AGENDA
JULY 28, 2026
CITY OF LAVON
PLANNING AND ZONING COMMISSION
CITY HALL, 120 SCHOOL ROAD, LAVON, TEXAS
6:30 PM

Re: Take 5 Oil Change
Zoning Change and Site Plan Review
LJA Job No. NTP3880
MyGov Submittal: June 26, 2026

Re: Take 5 Oil Change
Zoning Change and Site Plan Review
LJA Job No. NTP-40467
MyGov Submittal: May 29, 2026

SITE PLAN
REVIEW

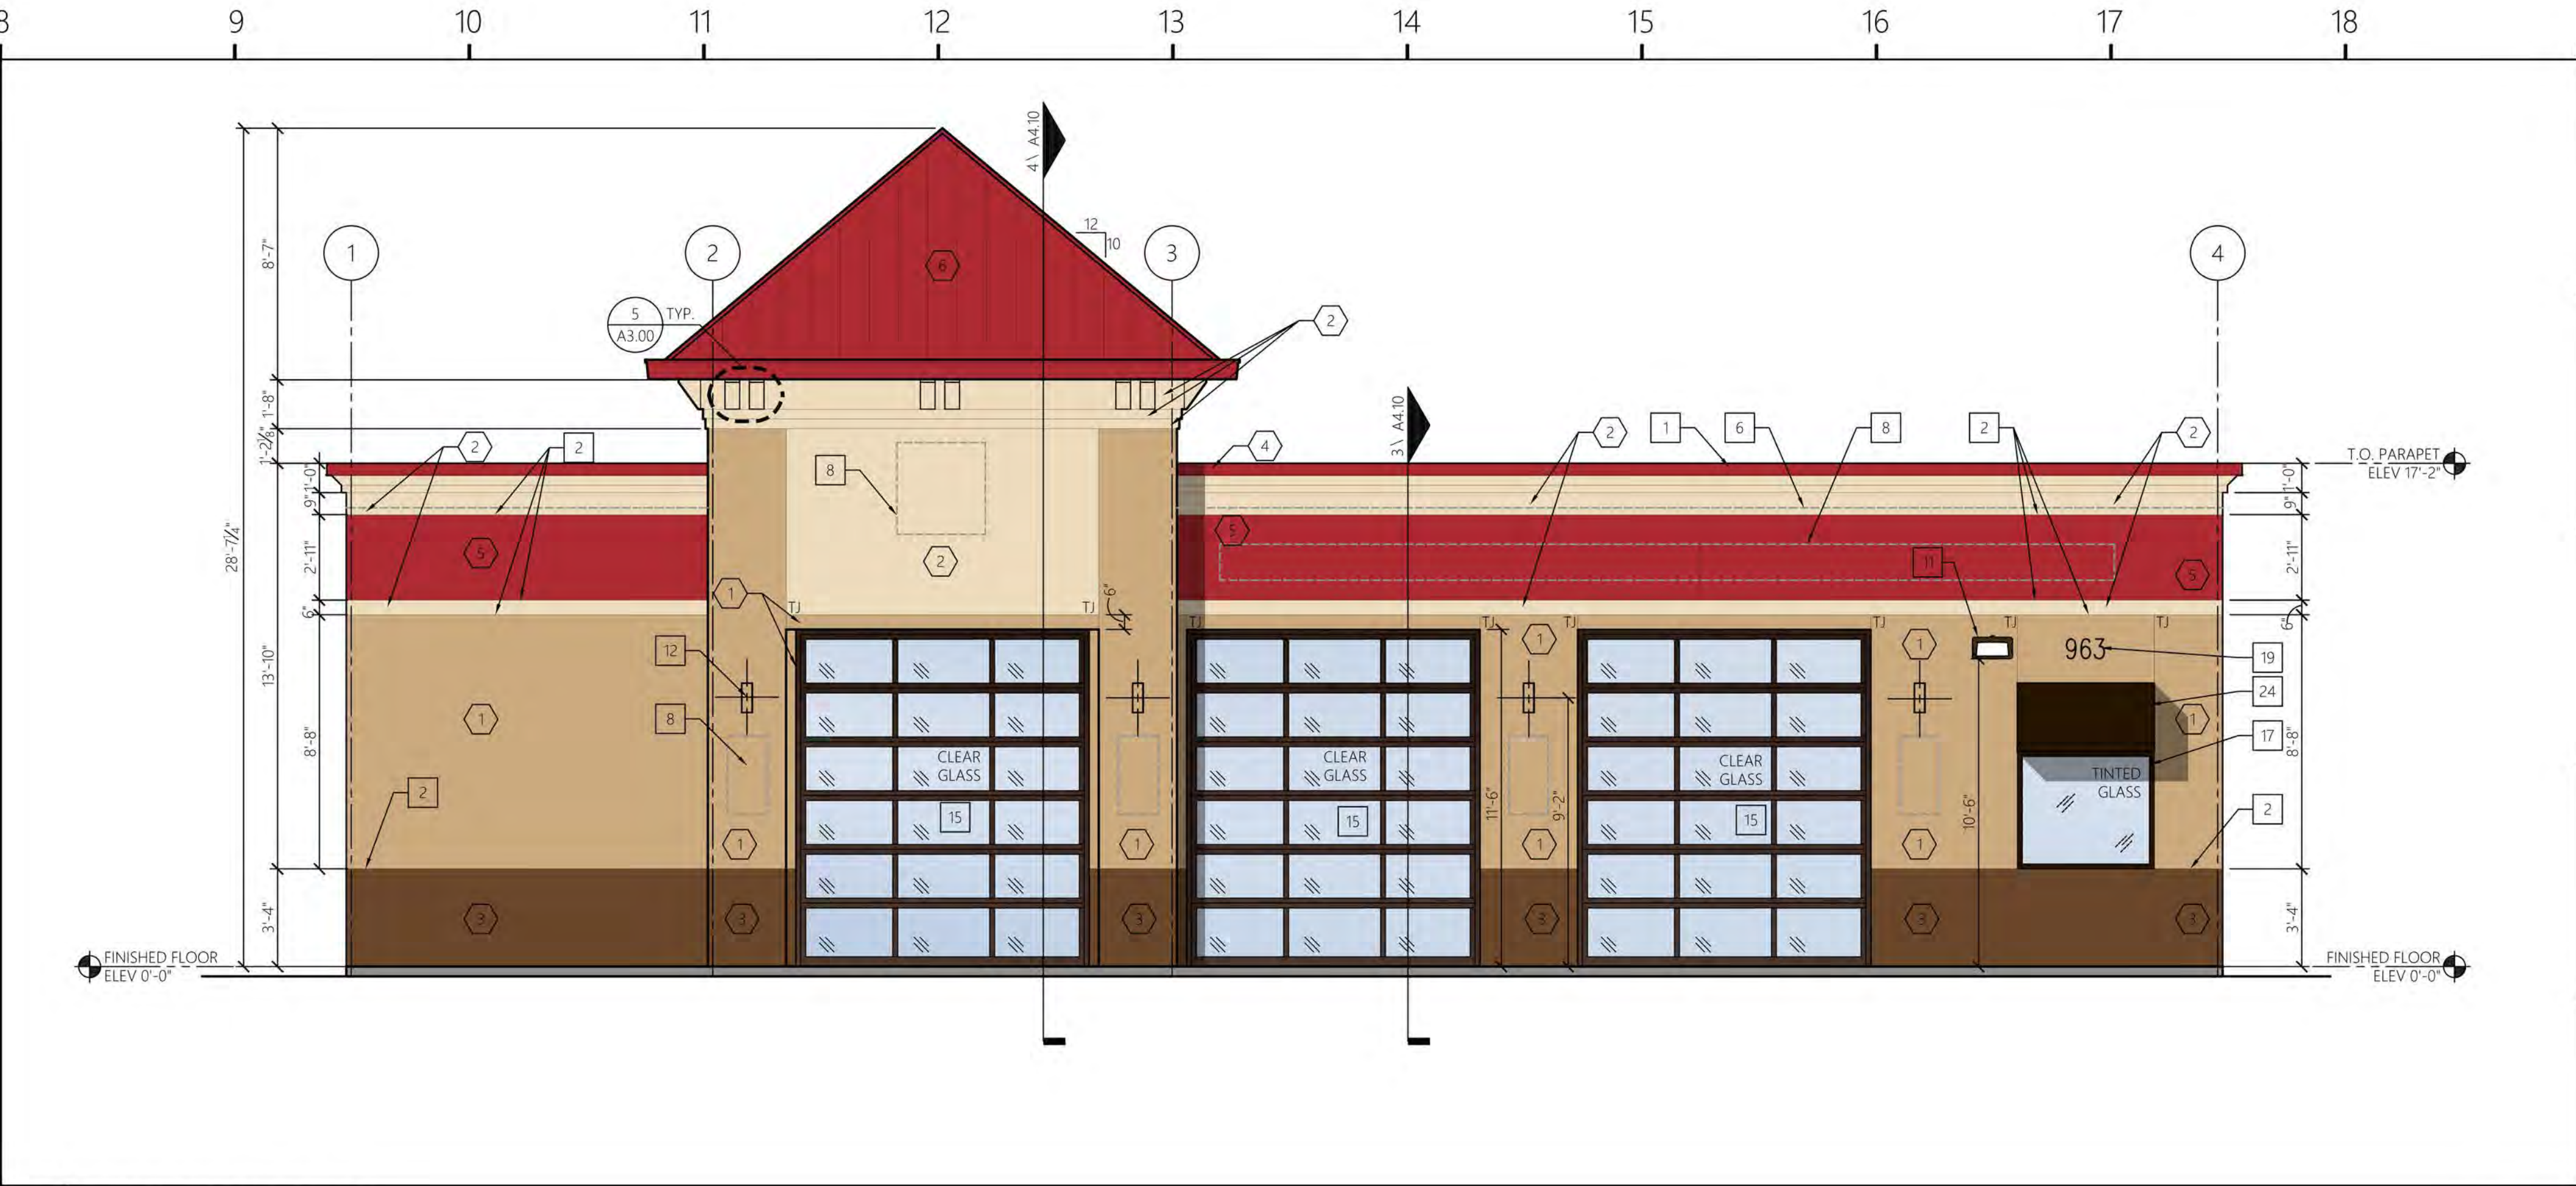
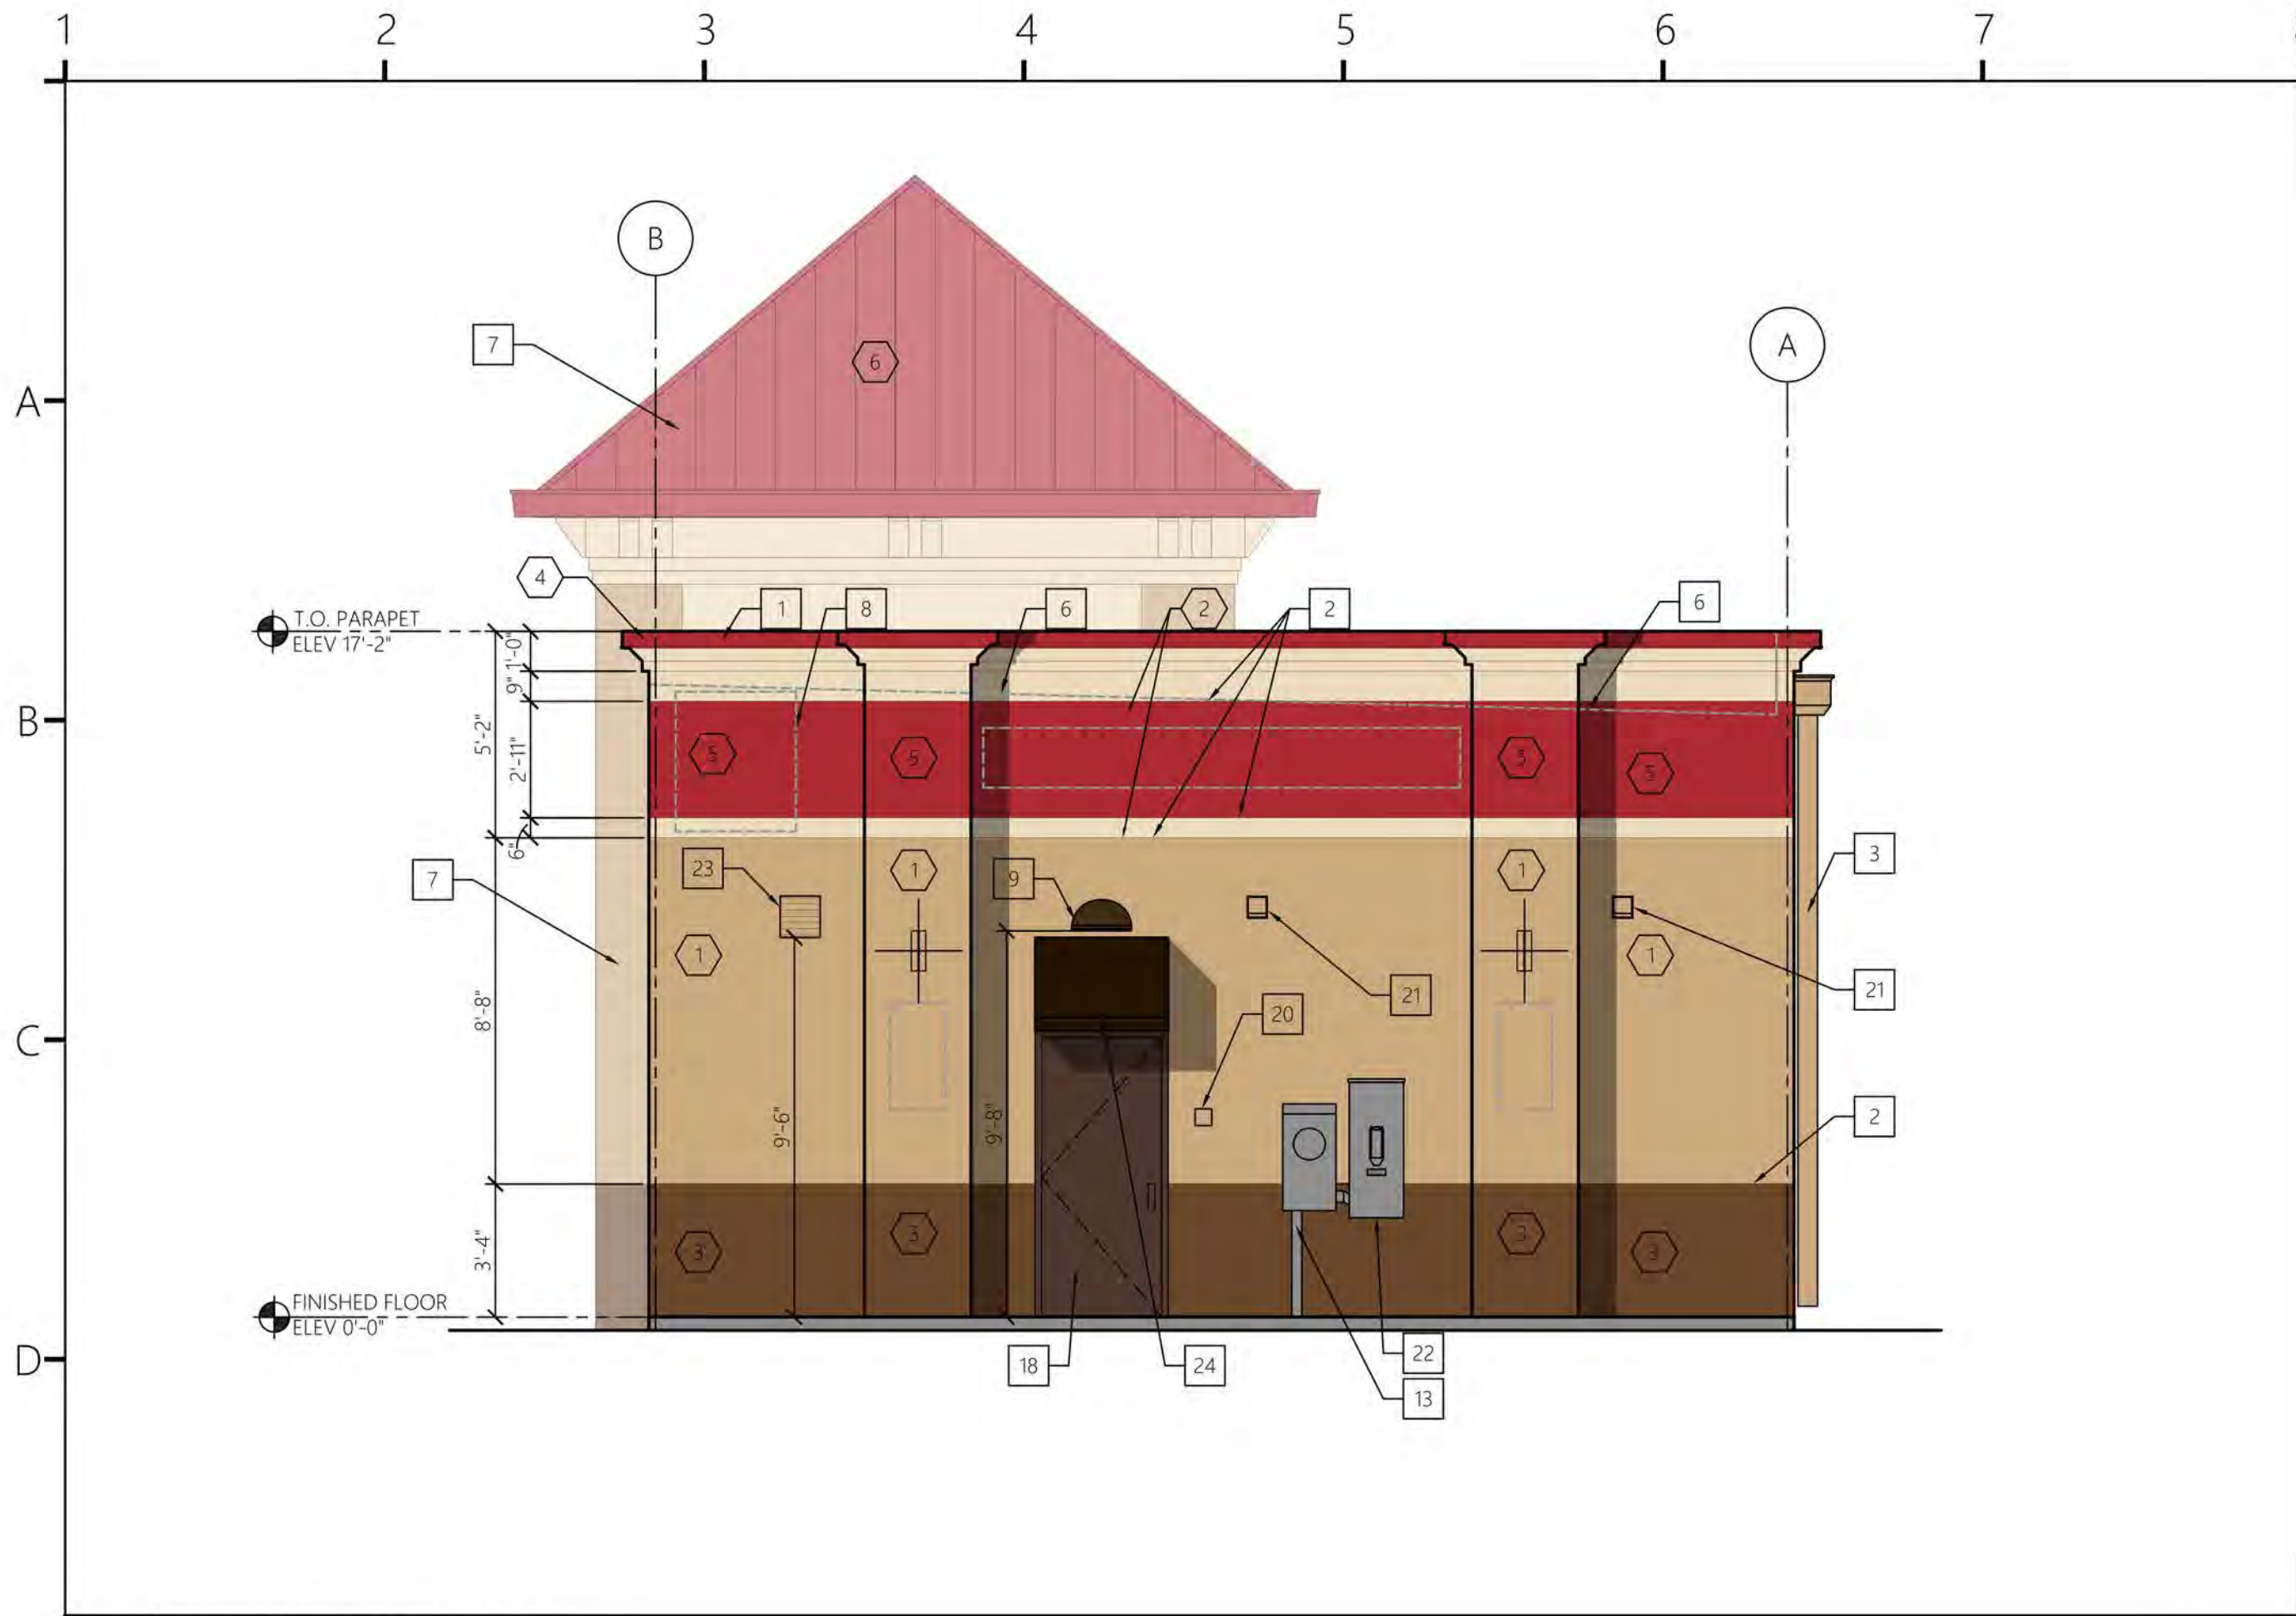
3. Revise the Site Plan to remove the topographic contour lines and utility lines. and provide on a separate Utility and Drainage Plans.
4. Revise the Site Plan to dimension and label all curb radii.

5. Revise the Site Plan and Landscape Plan to remove the indication of “private drive” and correct the label of the easement in that area to “24’ Fire Lane and Mutual Access Easement” to correspond with the associated Replat. Remove the linework and label for the 35’ Ingress Egress Easement” since it is proposed to be abandoned. Please ensure that any other changes of this nature, that 7 Brew has also received, are coordinated with this submittal as applicable. The “28’ Front Access Drive Easement” does not appear to be relevant and most likely should be removed. Due to the offsite features to the west being out-of-date and inaccurate (ex. layout, easement titles, etc.), they either need to be updated or removed from the site plan entirely and provided on a separate exhibit (so that the two sites together can be understood in terms of circulation).

6. Revise the Site Plan to remove key notes four, five, six, and 15. Label each proposed easements with the title to correspond with the associated proposed Replat.

7. Revise the Site Plan to relabel the dumpster enclosure as follows, “Six-foot tall dumpster enclosure with solid metal doors and masonry material to match the building.”

10. Revise the Site Plan to add a note stating: “All service activities shall occur entirely within enclosed service bays, and all service equipment shall be housed within the building.”

ALL SERVICE ACTIVITIES SHALL OCCUR ENTIRELY WITHIN ENCLOSED SERVICE BAYS, AND ALL SERVICE EQUIPMENT SHALL BE HOUSED WITHIN THE BUILDING.

Sheet Number:
A3.00

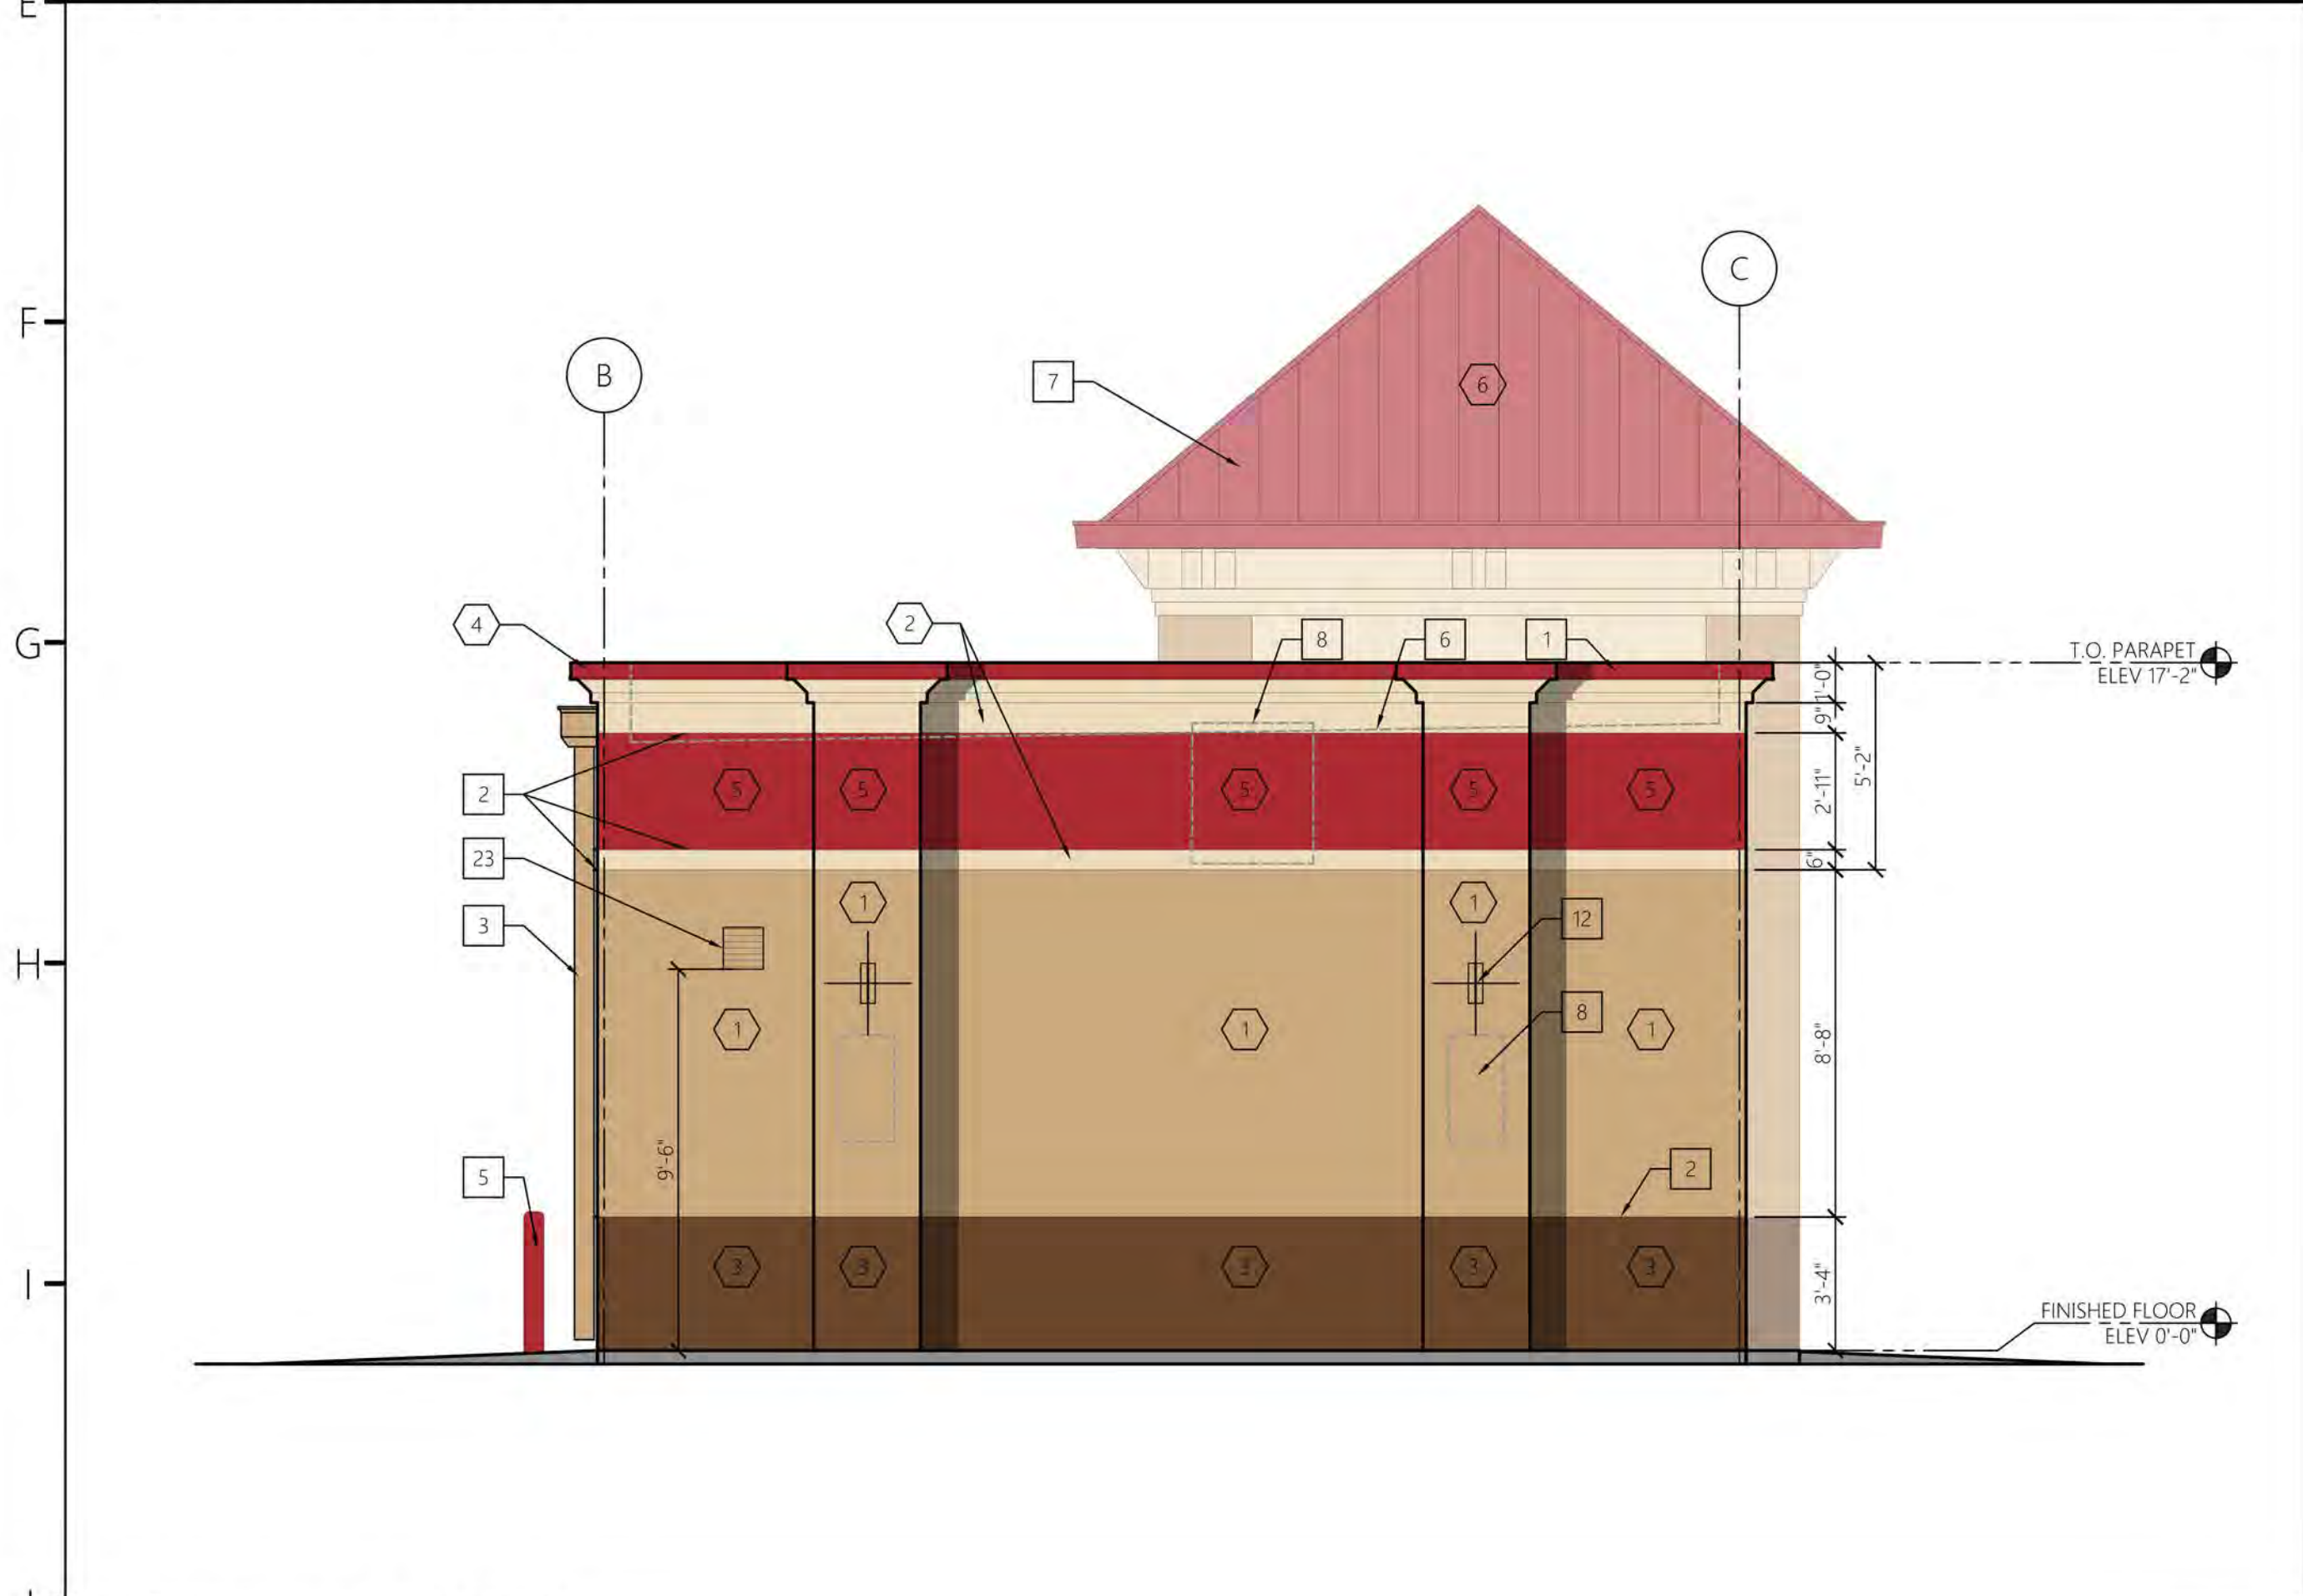
1. Remove Building Elevation keynotes two and three (which reference a plan sheet that was not included with the submittal) or add referenced Sheet A7.00 to the plan set.

14. Revise the Building Elevations to label the directional orientation of each elevation.

16. All light fixtures shall be both shielded and downward facing. It appears that the LED light fixtures shown on Building Elevation 3 do not comply with this standard. Revise the Building Elevation accordingly.
